**TOWN OF FAIRFAX
STAFF REPORT
Department of Planning and Building Services**

TO: Fairfax Planning Commission
DATE: April 18, 2013
FROM: Jim Moore, Director of Planning and Building Services
 Linda Neal, Senior Planner
LOCATION: 17 Woodland Road; Assessor's Parcel No. 003-053-13
PROJECT: 50% remodel/addition to a single-family residence
ACTION: Hill Area Residential Development Permit, Design Review, Excavation Permit and Parking Variance: application # 13-01
APPLICANT: Rich Rushton, Rushton Chartock Architects
OWNER: Daniel May and Kim Teevan
CEQA STATUS: Categorically exempt section(s), 15301(e)(1)

17 WOODLAND ROAD

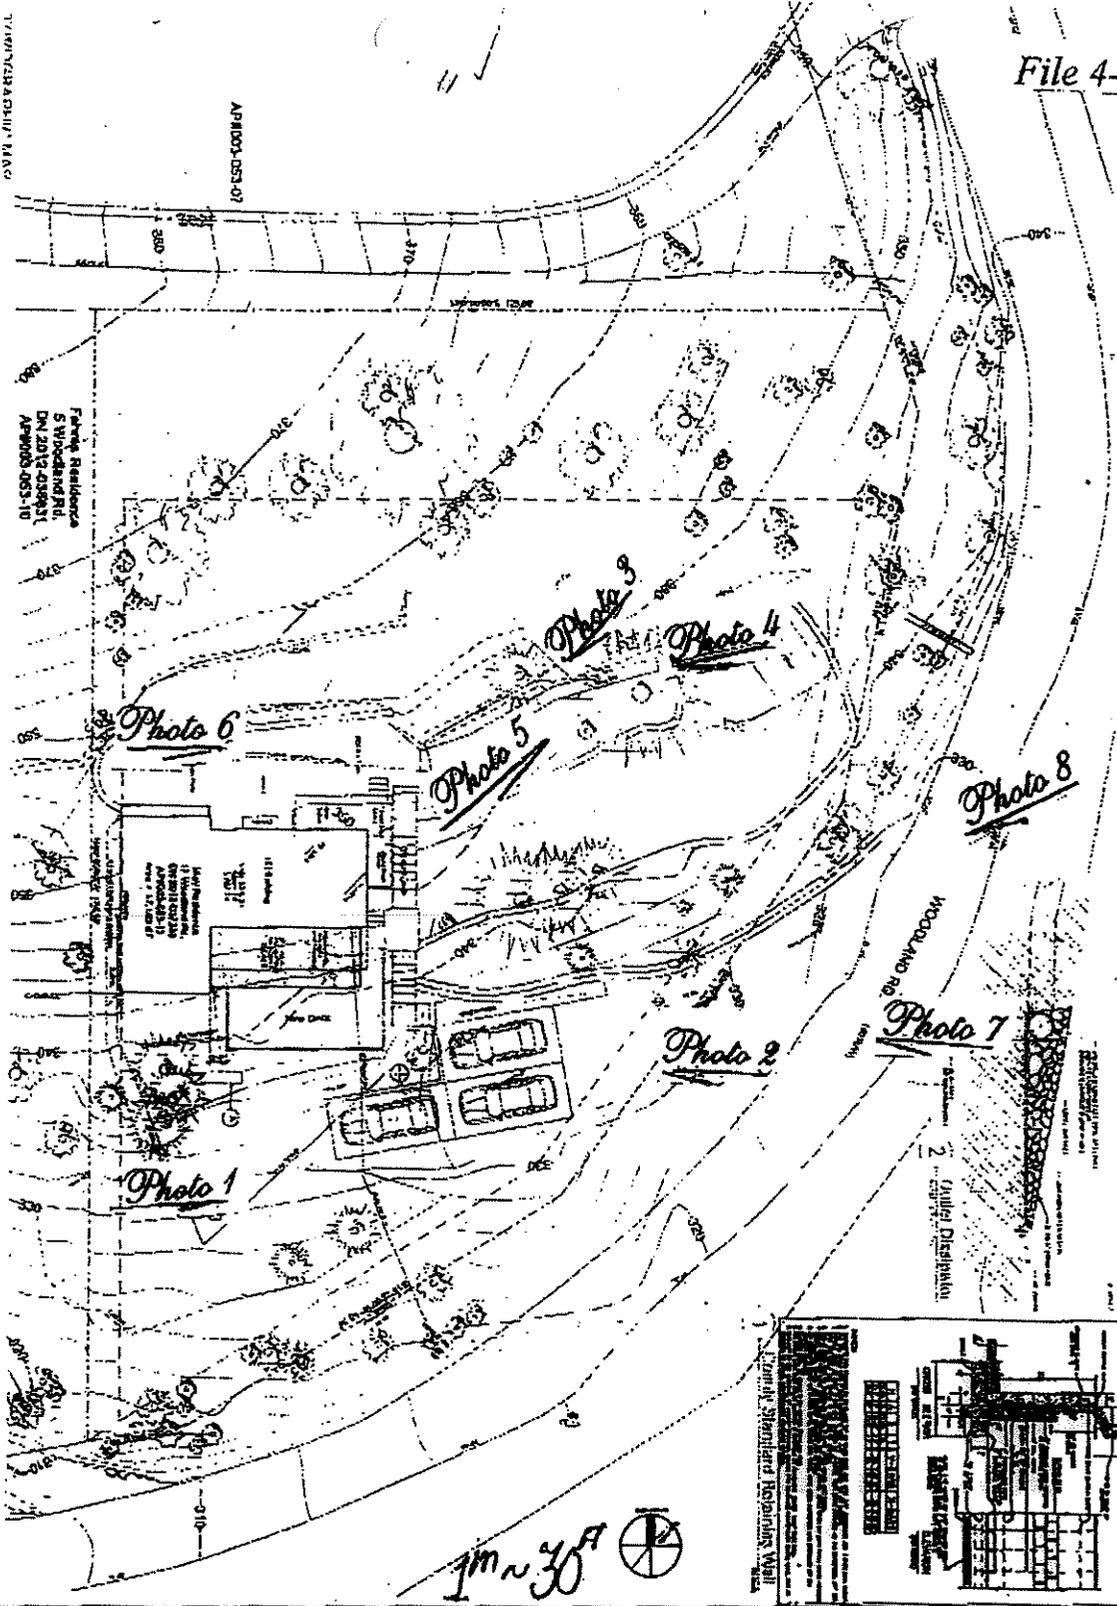
Indications are that the most viable means of dispersing the rear roof and rear yard drainage would be to carry it to a conventional dispersion flume sited on the level bench to the east (photo 5). Such a flume is shown on Sheet A2.1.

As indicated in the 10/23/12 letter from the Town Engineer, the contours on the Site Plan are generalized and imply some cut slopes to be shallower than actual.
